Regulatory Updates on Building Plan Requirements

BUILDING PLAN & POLICIES DEPARTMENT
BUILDING PLAN & MANAGEMENT GROUP

ACCESSIBLE ROUTE PROVISION

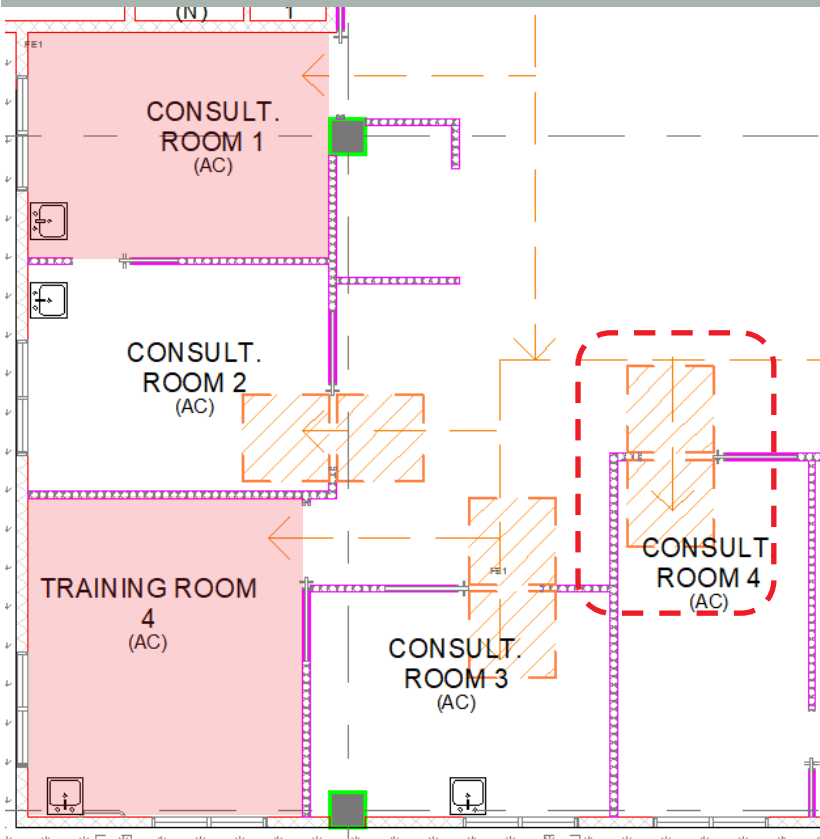
- ✓ **ALL Consult & Training Rooms to be provided with accessibility**
 - **Manoeuvring spaces** to be provided on both sides of door
 - Sliding door: 1200x1200mm clear floor space and 300mm clear space from leading door edge
 - **Accessible route** cannot be shown to rooms if doors are not accessible (**all rooms must still be made accessible**)

Factory / Warehouse (2019 Code)

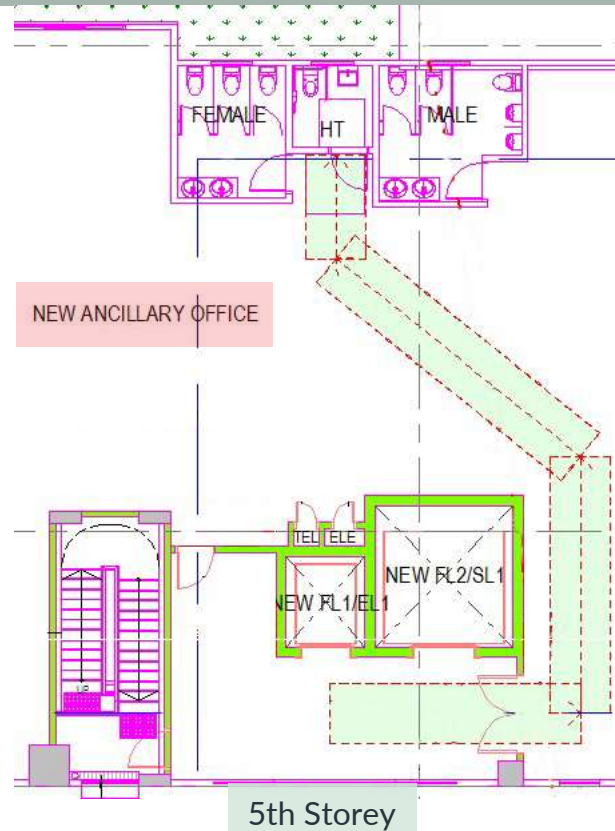
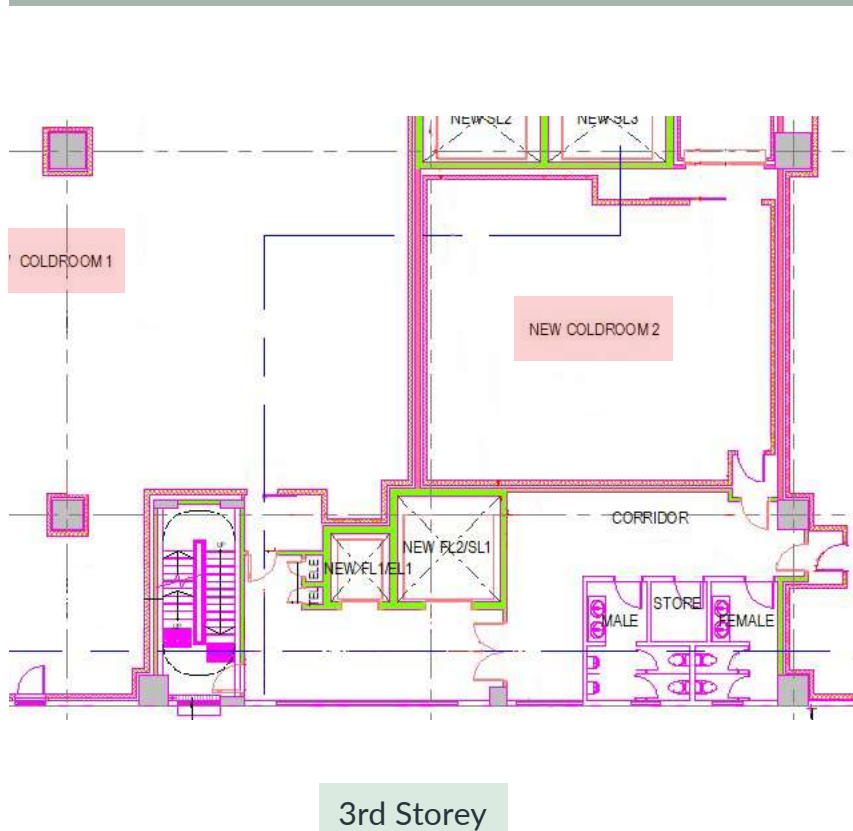
- ✗ **Coldrooms:**
Accessibility not required
- ✓ **Ancillary office:**
Accessibility required
- Accessibility only **exempted** for **ancillary office** in developments handling **chemicals, toxic materials and potentially explosive compounds**

ACCESSIBLE ROUTE WIDTH

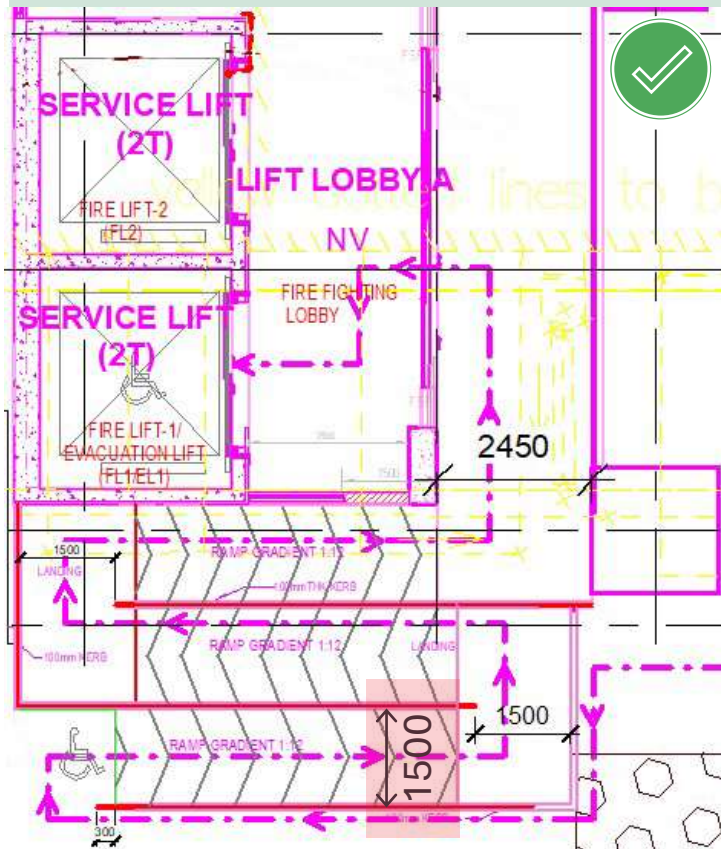
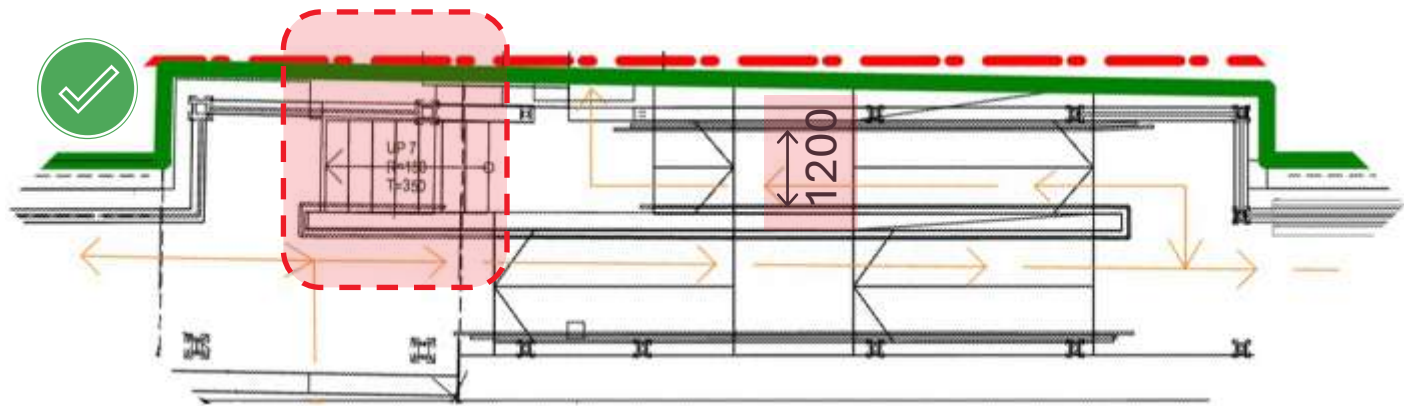
1500/1800mm clear ramp width in accordance to Table 3
 unless
 Alternative stepped approach provided adjacent to ramp and total rise does not exceed 1200mm
 ➤ 1200mm clear ramp width acceptable

ACCESSIBLE ROUTE WIDTH

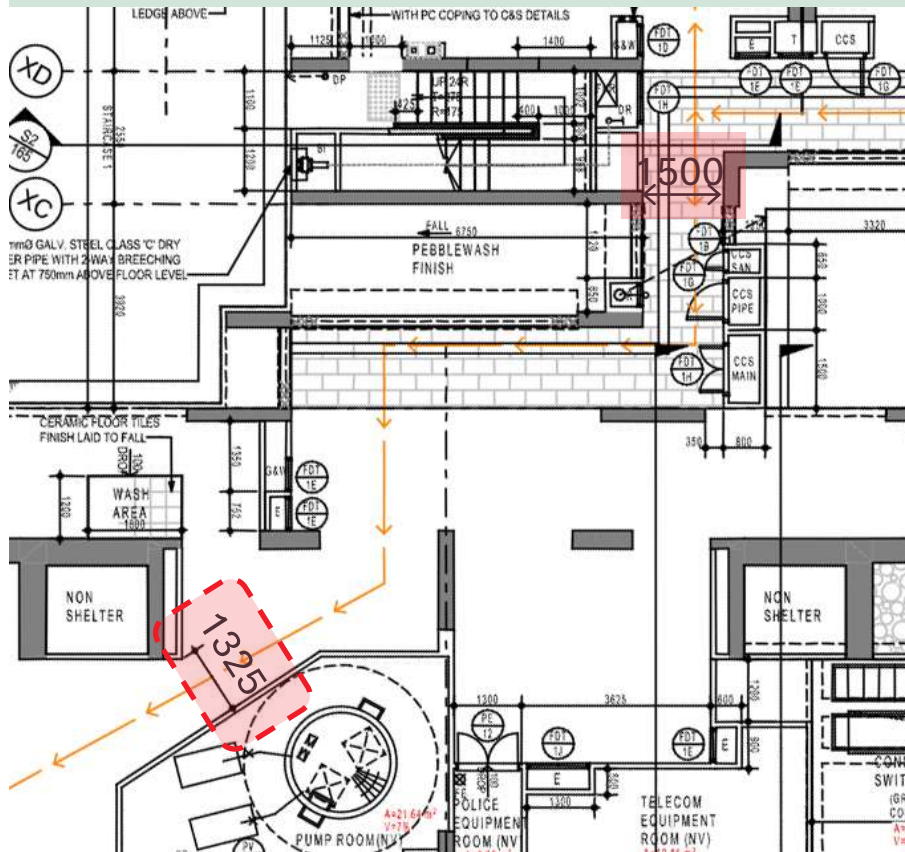
- **Primary accessible routes** are shown by route marking on plan
- **ALL areas along the primary accessible routes** must meet the minimum 1500/1800mm width for the respective building types

MODE OF VENTILATION

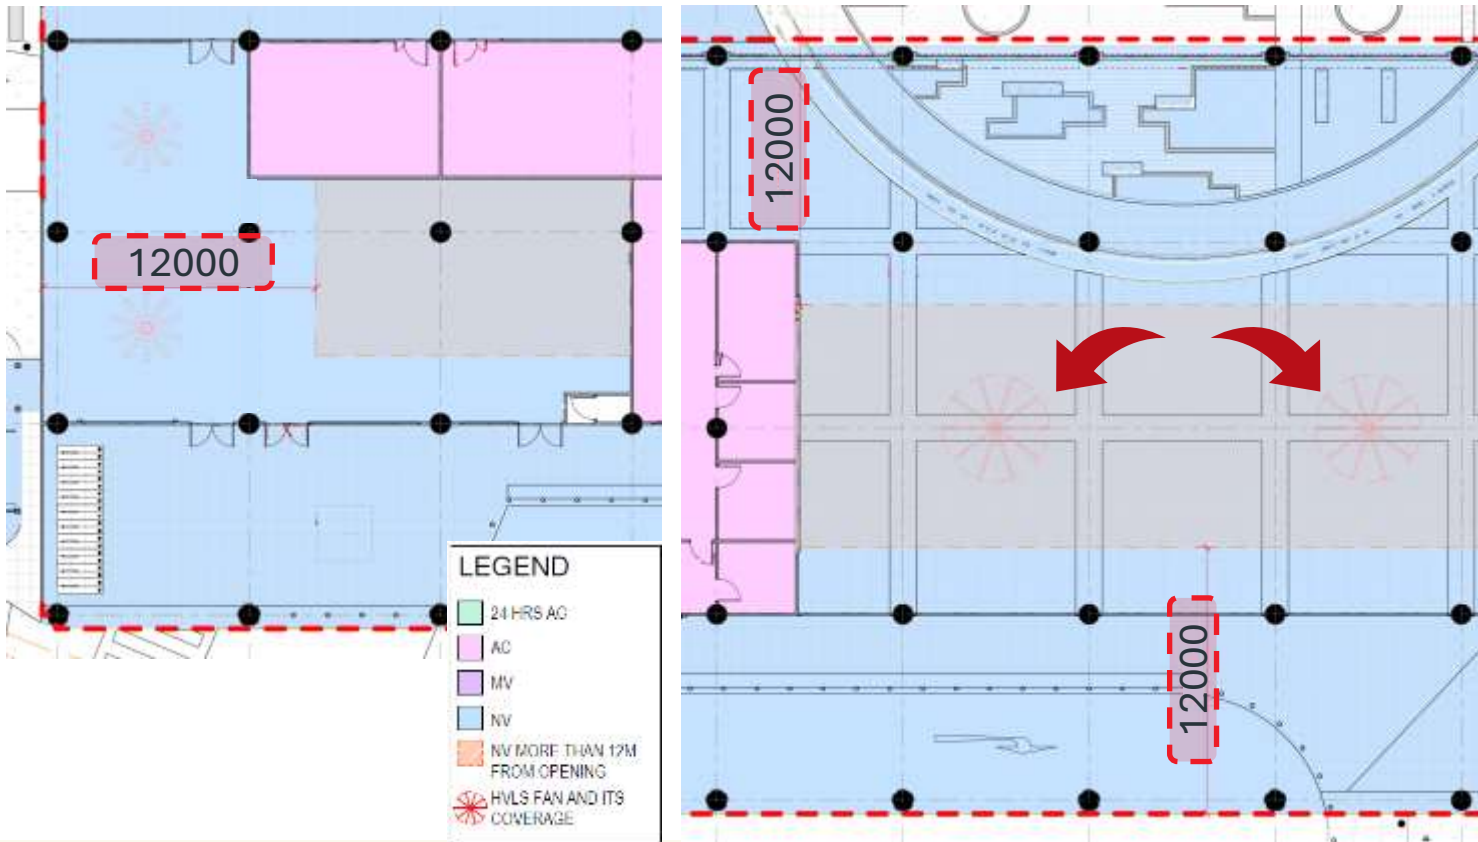
- **Natural ventilation** *cannot* be provided to areas >12m from window/opening
 - **Non-compliant** if shown on plan
- Provision of **recirculating fans** is **not an Acceptable Solution** as it does not draw in fresh air
 - **NV space provided with mechanical assistance** (e.g. jet fans/HVLS fans), supplemented with **CFD reports** demonstrating performance compliance to SS553 on ventilation rates, *can* be considered as **Alternative Solution** (subject to approval)

Warehouse

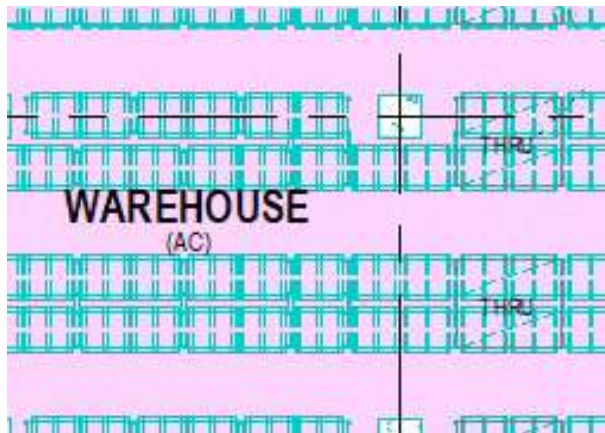
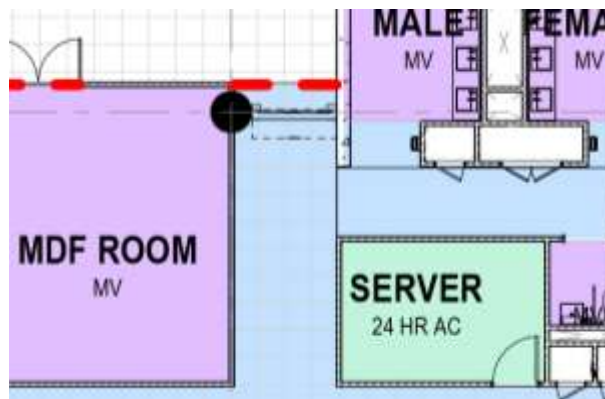
- **Fresh air vents** *must* be provided to all air-conditioned areas
- **Basic/Standard air-conditioning units** do *not* cater for fresh air intake

OPENINGS WITHIN SS

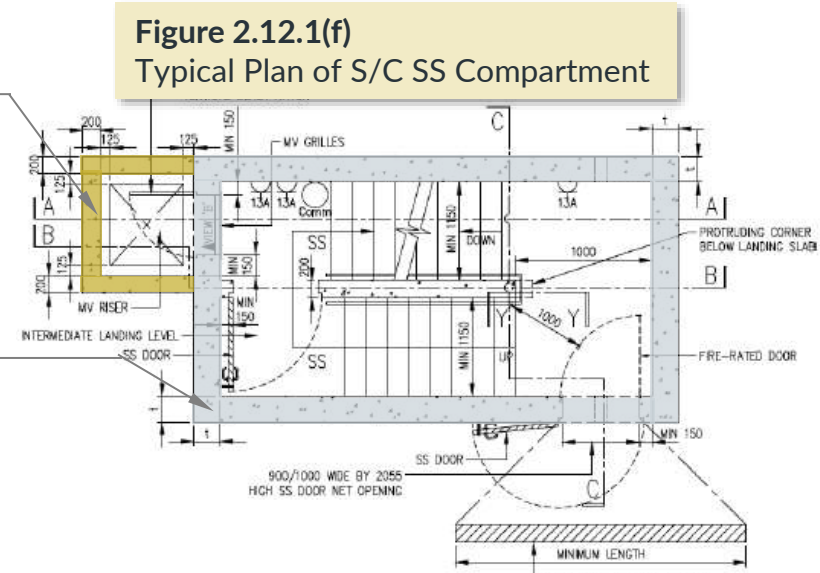
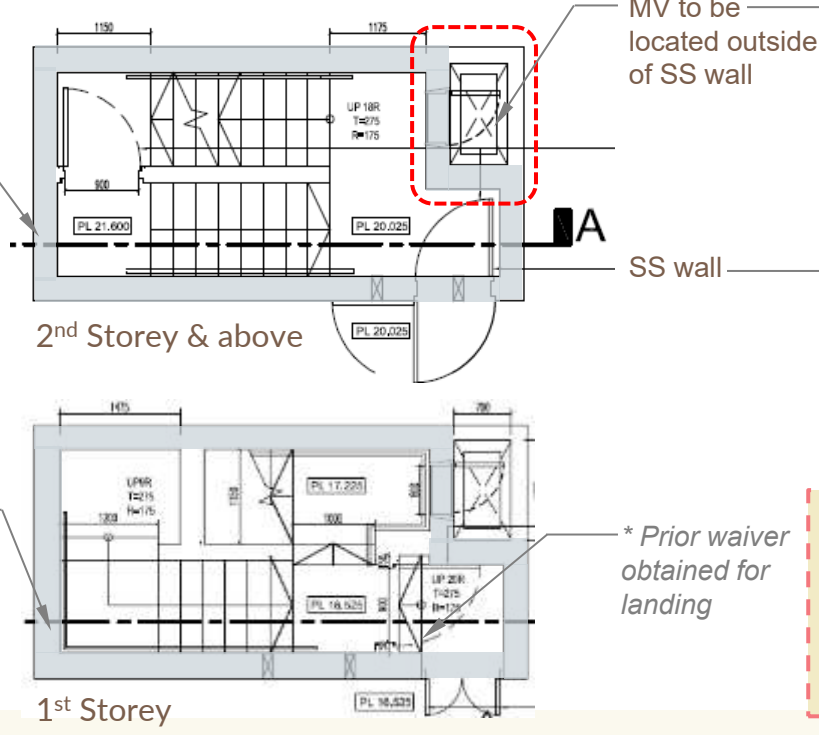
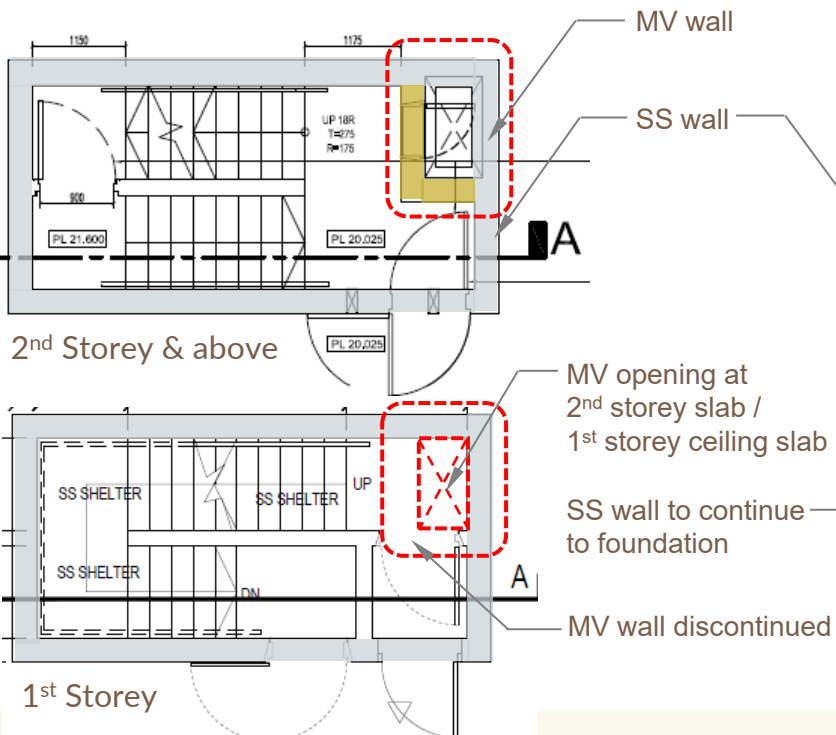
✗ MV located within SS

The proposed MV opening at SS slab differs from typical design details, resulting in operational challenges and reduced robustness of SS system.

✓ MV located outside SS (No openings in SS)

FIRE DOOR AT SS ENTRANCE

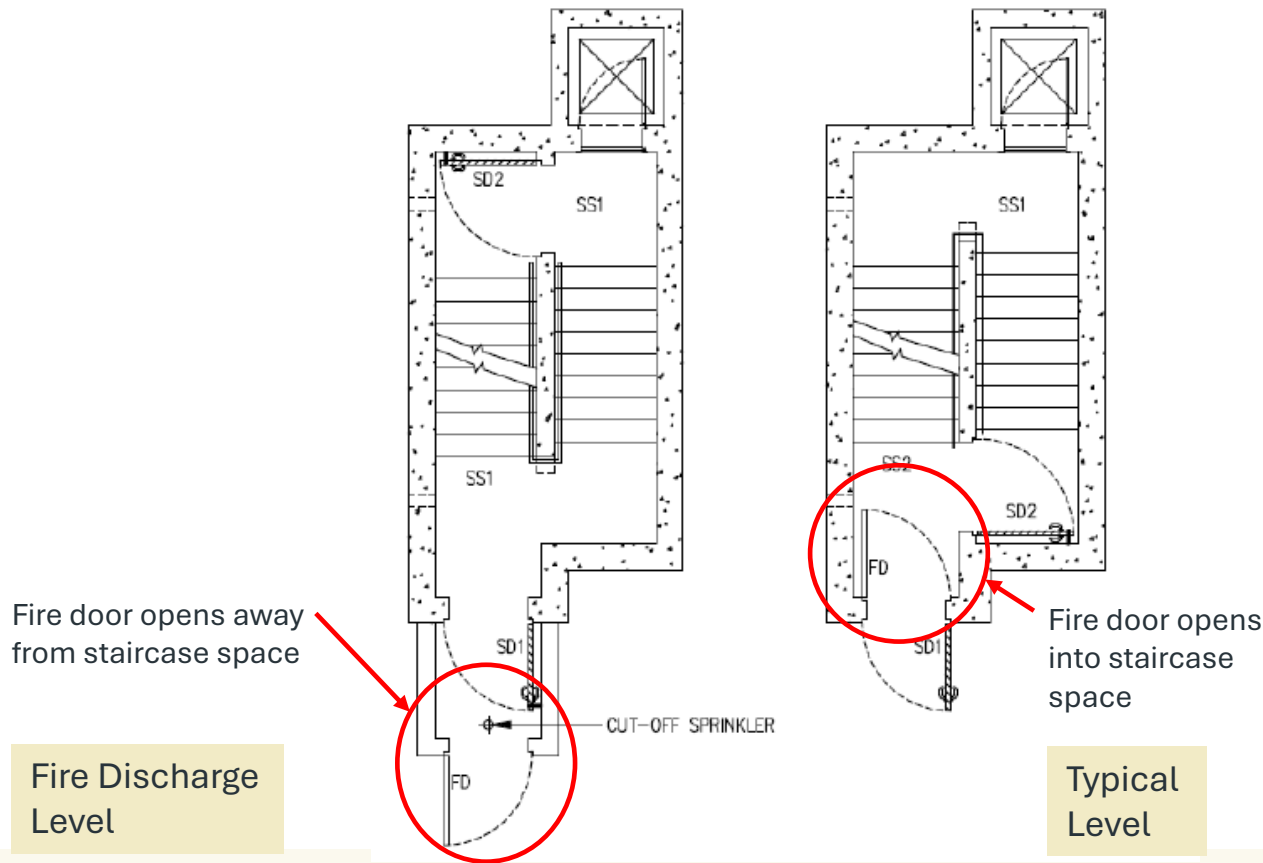
- Fire Discharge Level**
- Fire door at SS entrance to open away from staircase, so as to be opening **in the direction of exit travel**
- Typical Level**
- Can be designed to open **into staircase**

FIRE DOOR AT SS ENTRANCE

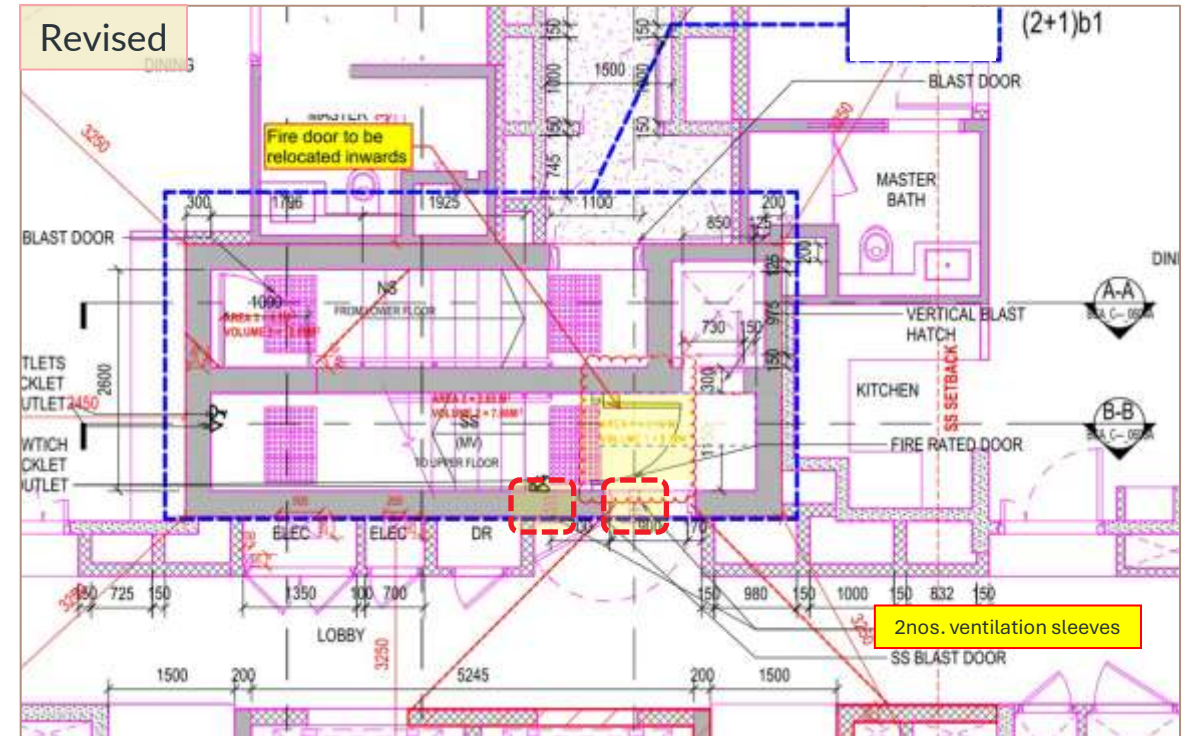
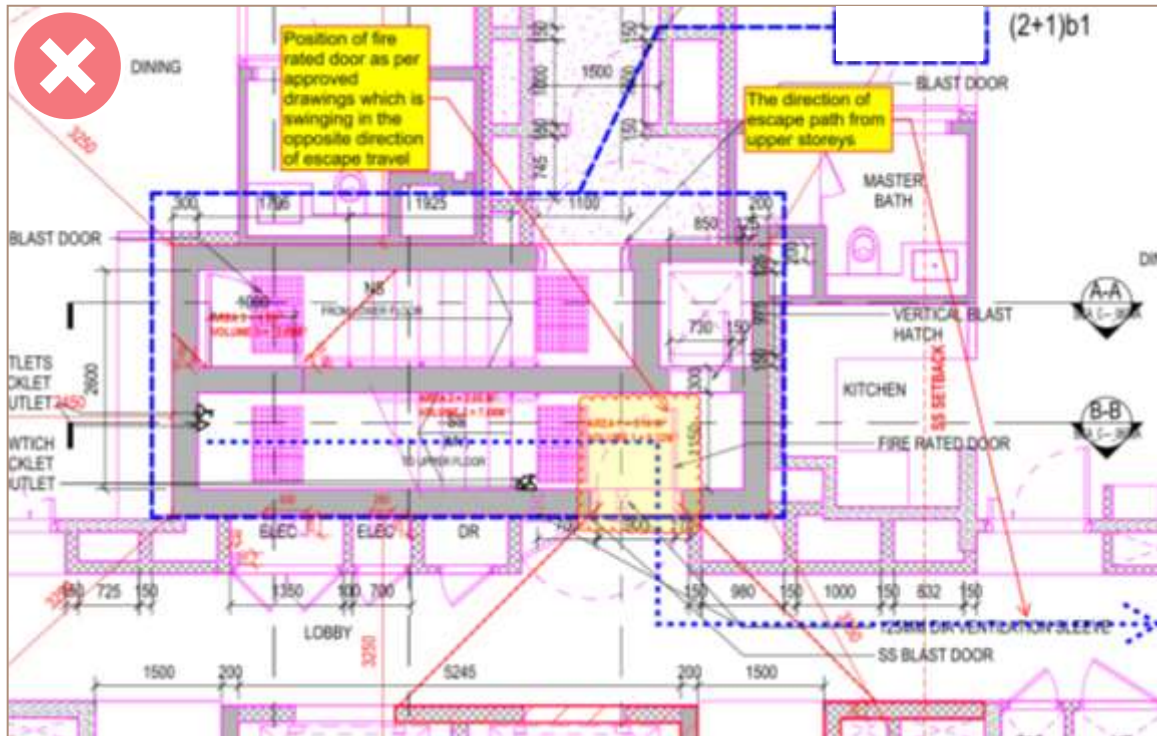
- Fire door at fire discharge level opening into staircase

- Relocate fire door inside staircase such that fire door can open outwards
- *Resulted in abortive works*
 - New RC wall inside staircase
 - Provision required for air flow to SS compartment (peacetime) as well as SS space behind fire door (wartime)

Void beside staircase

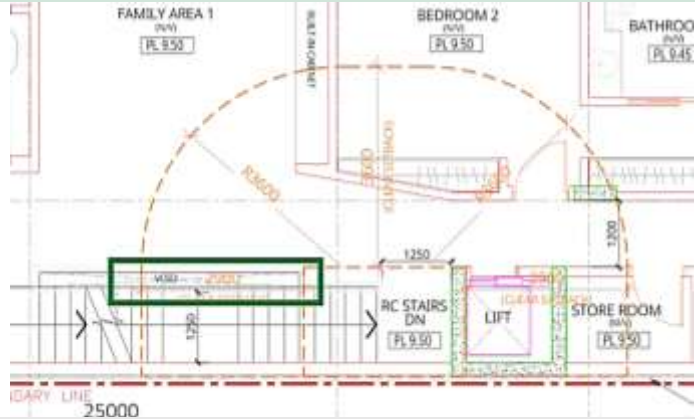
- Setback distance follows **height of staircore**

Shared HS wall with lift core

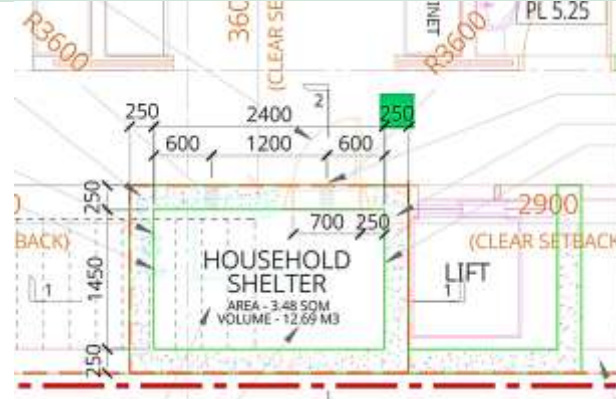
- Additional 50mm thickness
